RE: Hugh Harris
9 Sterling Road North
Application for Site Plan and Wetland Permit Approval

Finally, in their previous comments to the Planning Board, Kellard Sessions dated October 22, 2021 offered additional comments and/or requested clarification on several items. Responses to those comments are provided in the same order as provided.

**SITE PLAN W/
 APPROVED SSDS**

PROPOSED
IN-GROUND POOL
COVERAGE PLAN

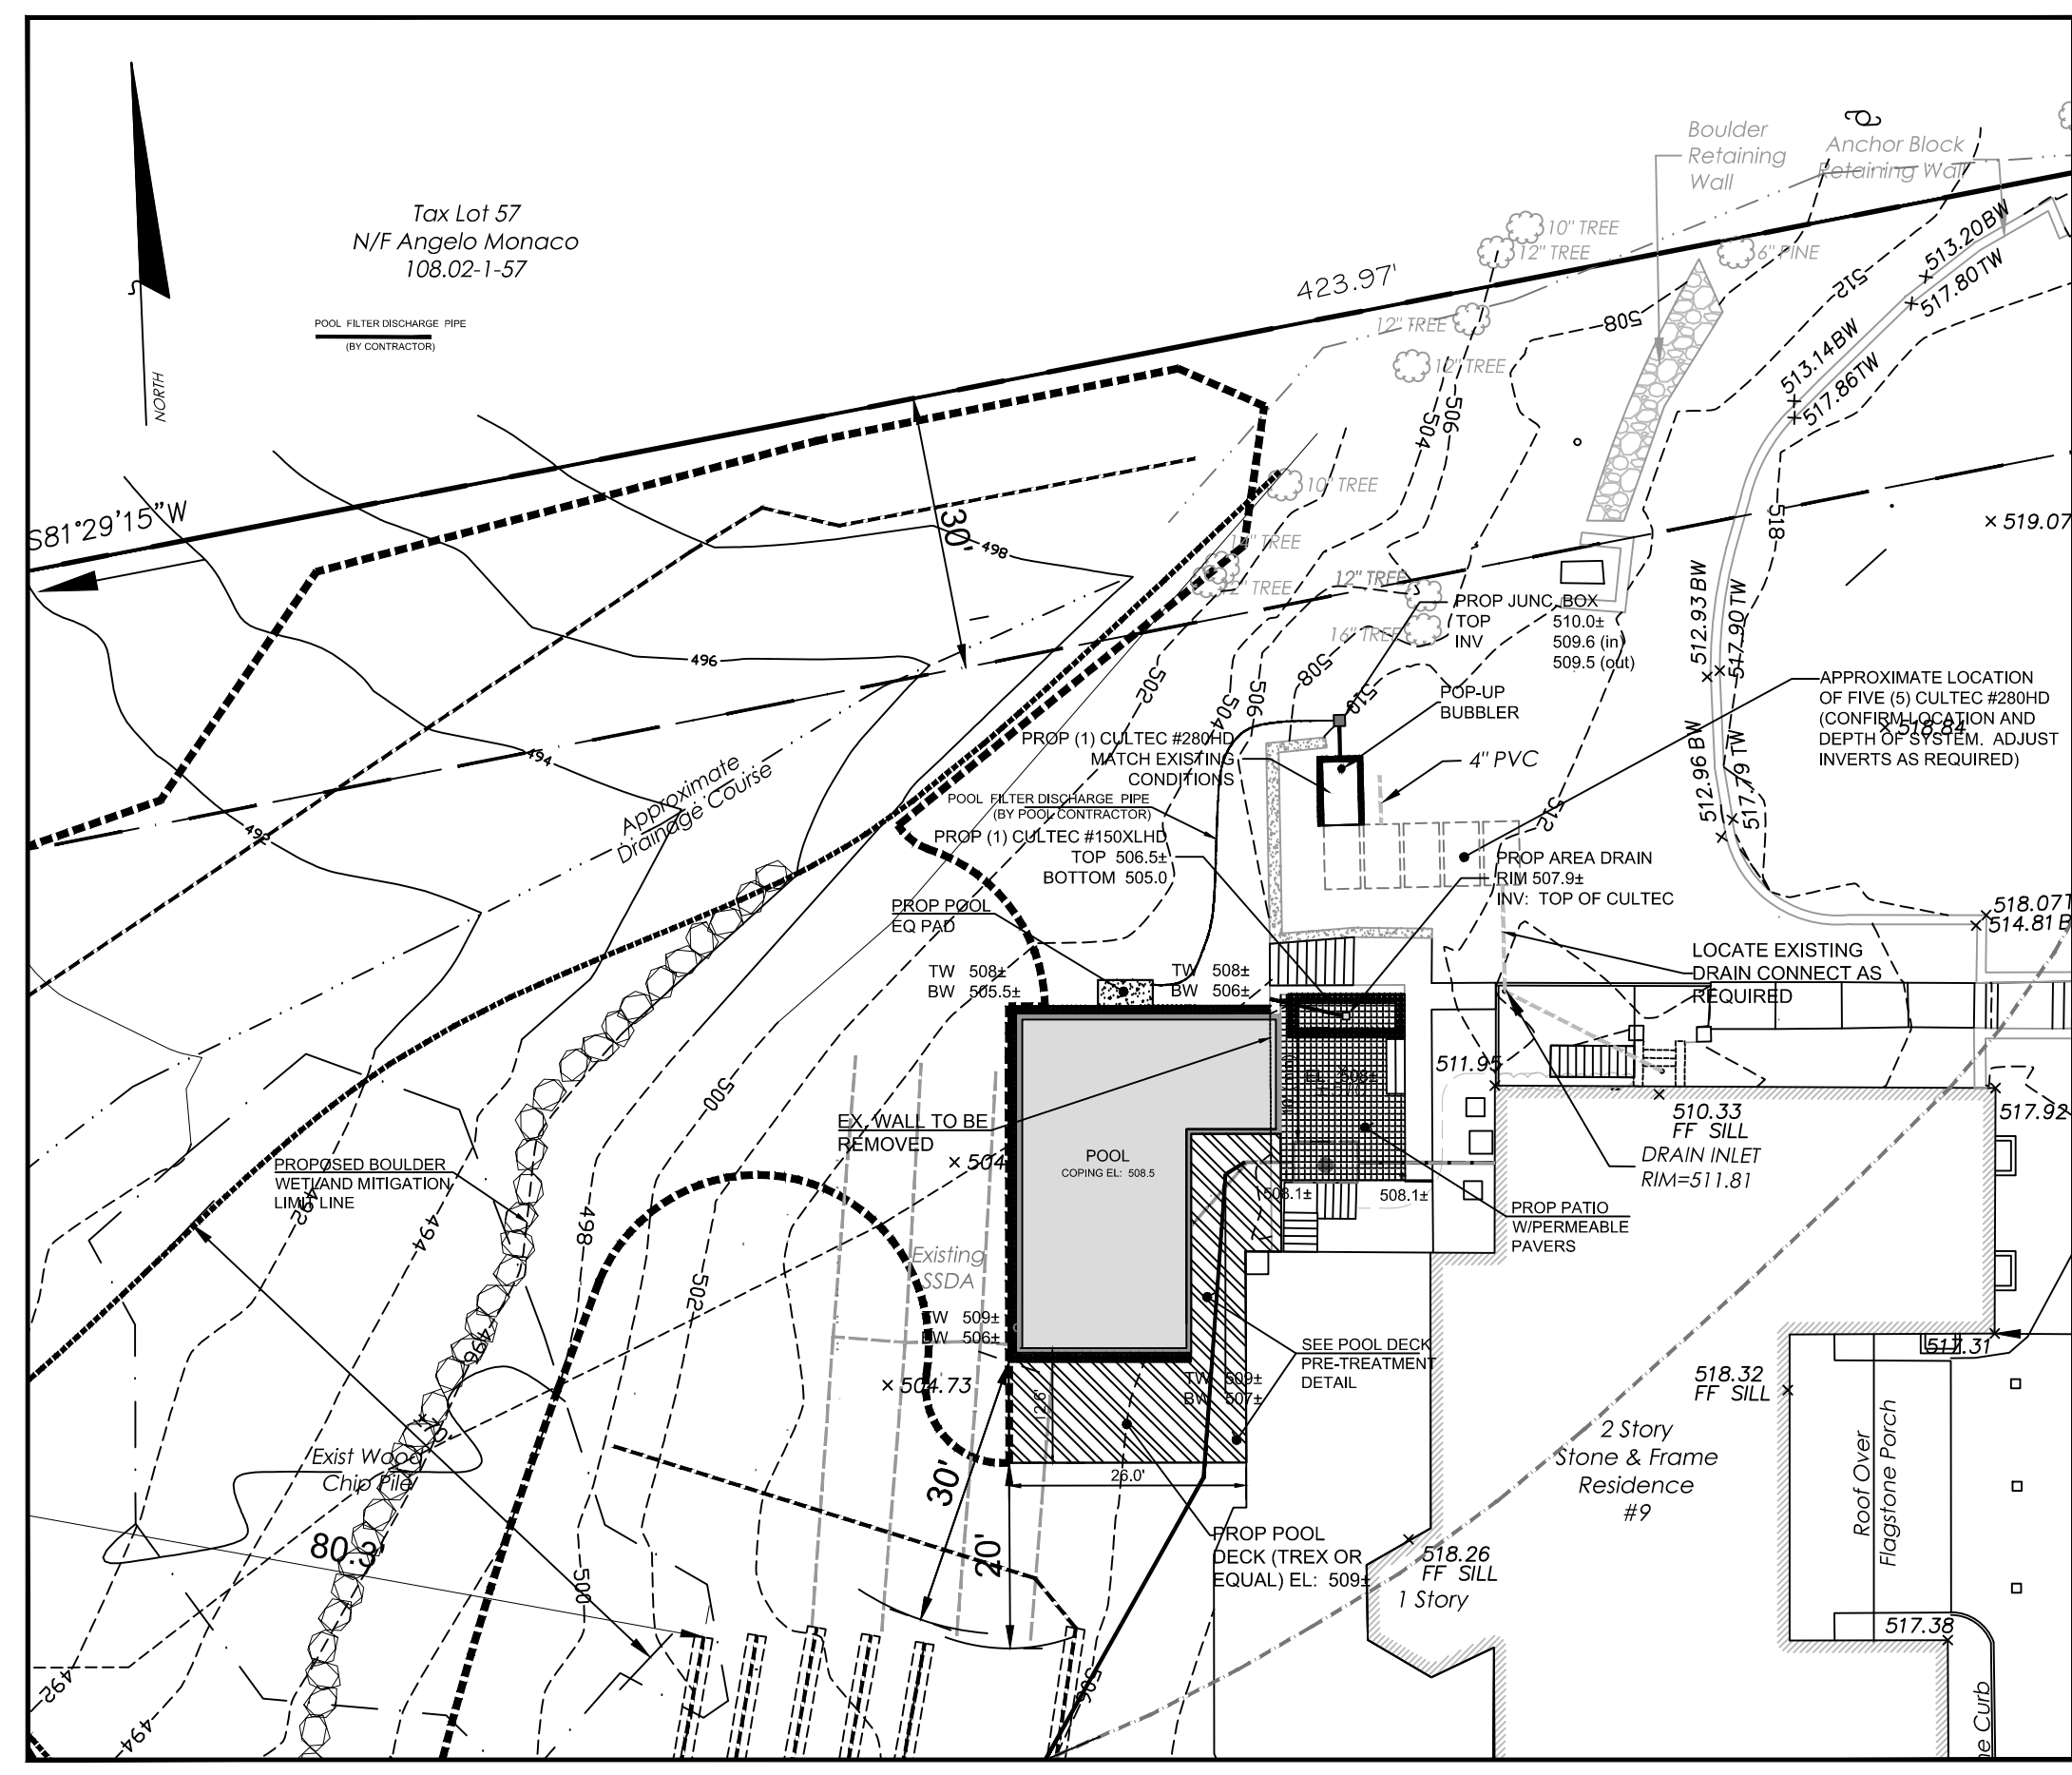
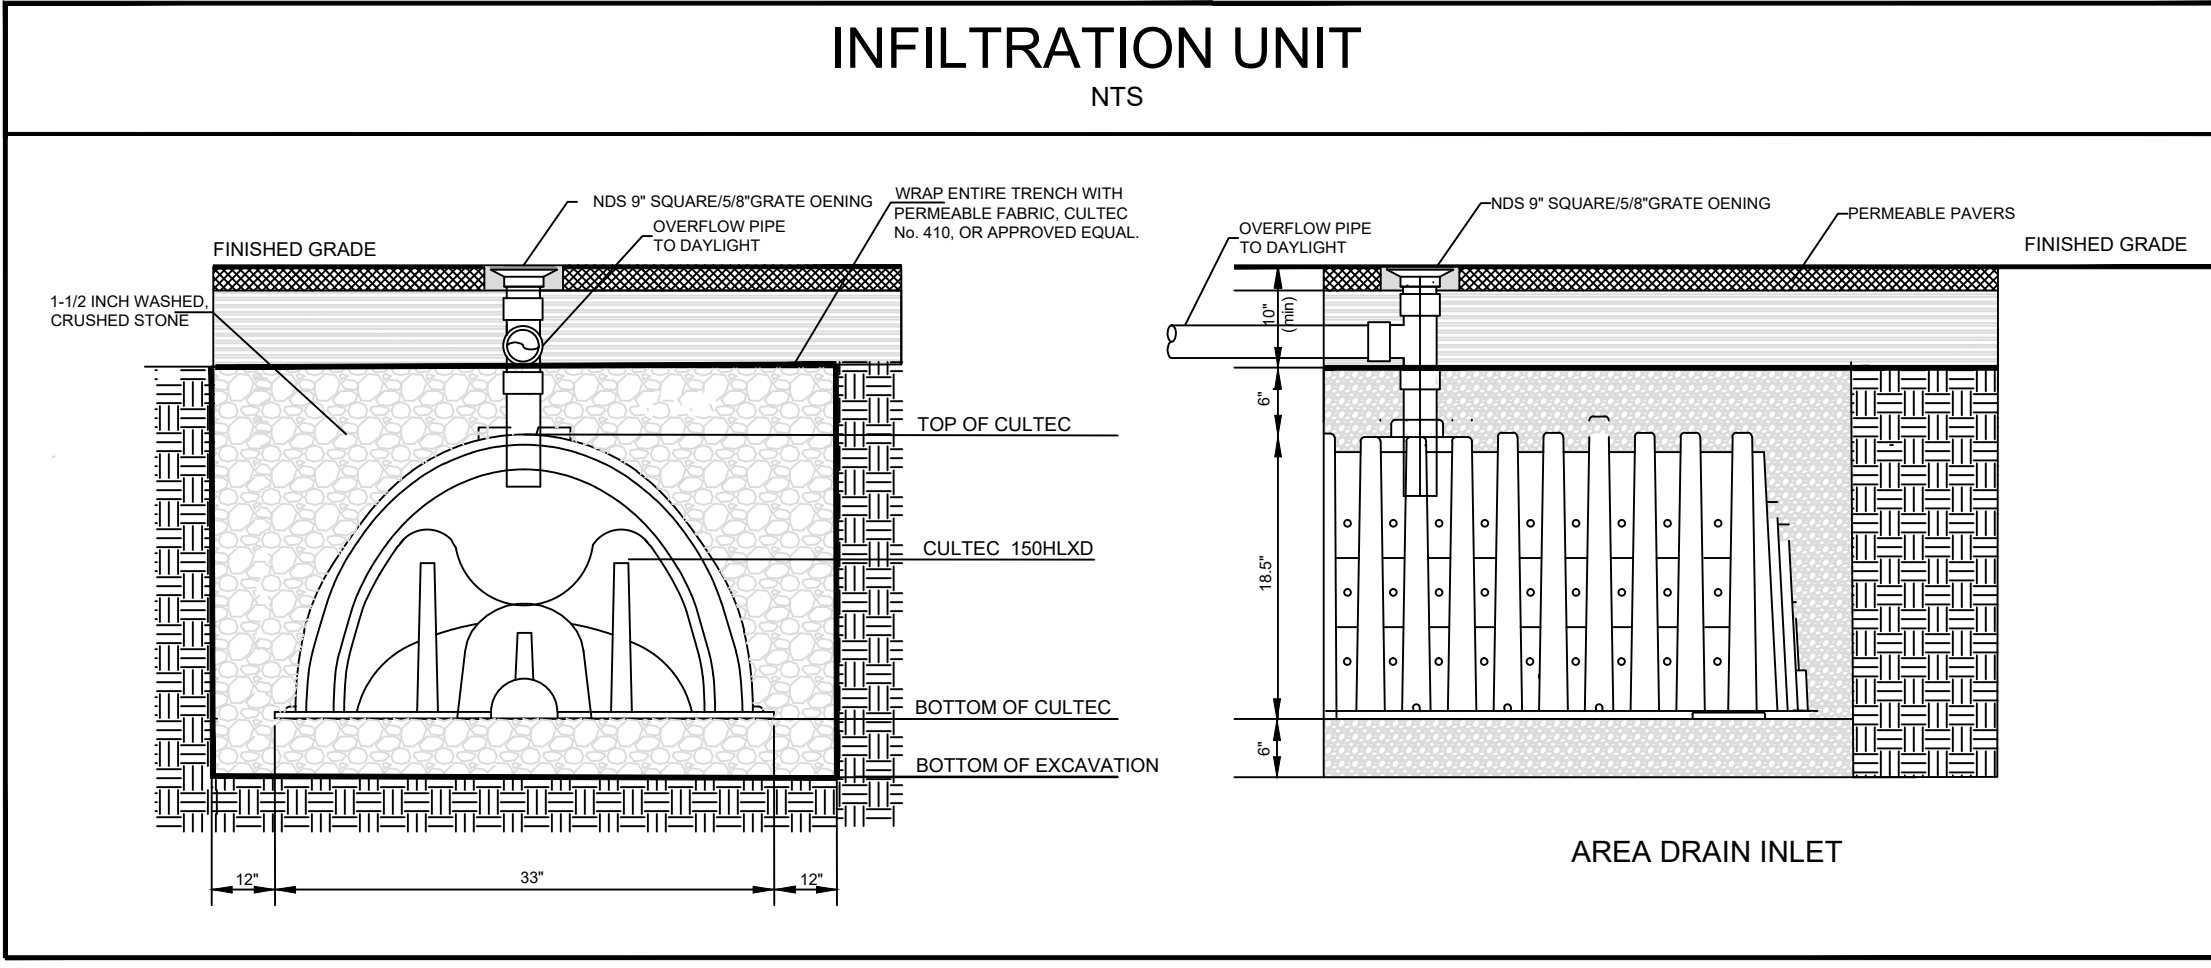
6. *The Renewed Remediation Permit (#NOC 2022-15R) is attached as requested. Also attached is a copy of the Approved Plans.*
7. *The typographic error relative to the infiltration unit has been corrected.*
8. *See Expanded discussion regarding the stormwater mitigation system below.*
9. *The referenced retaining wall was constructed under a separate permit and plans designed by different consultants. In lieu of reconstructing the walls, the property owner has secured a Certification Letter from a NYS Licensed Engineer stating that the wall was constructed in accordance with specifications and that its height is within design standards.*

We appreciate the Town Engineer's reluctance to accept the concept of pumping stormwater or pool winterization discharge into a slightly elevated mitigation device – in fact under most situations we would agree. However, consider the following:

Based upon the current plan, the volume of water during the winterization process controls the size of the new mitigation system. Importantly all discharge associated with drawdown, backwash, drainage, rinse cycles, and similar functions are all handled by the pool pump motor (typically ½ Hp). The slight difference in elevation between the pumps and the existing Cultecs is minimal and therefore well within the range of any pool filter pump. It is also unlikely that a homeowner would not maintain the pool filtration equipment functioning at its optimum efficiency, so it would follow that the once-a-year winterization process and perhaps weekly back-flow cleaning of filter will occur without interference.

To address the additional volume of winterization discharge a fifth Cultec Unit is proposed.

As noted above, the original driveway was approximately 8,000 square feet of asphalt and stone pavers. Under that approval, Mr. Harris removed the pavement and replaced it with permeable pavers. Although open to discussion, the typical RCN associated with impervious surfaces is 98, depending upon the manufacturer, permeable pavers are assigned an RCN as low as 75. However, for the purposes of this discussion an RCN of 88 was assumed.

RCN	98	Runoff Depth	6.2"	Volume	4,130 cf
RCN	88	Runoff Depth	5.1"	Volume	3,400 cf
Result					- 730 cf

Note that the area associated with the Trex Deck and Patio “creates” less than **50 cf** of runoff volume. Further, as the design point associated with all runoff from the property is in the northwesterly corner of the site, it is suggested that the intent of the stormwater mitigation requirements have not only been met, but exceeded.
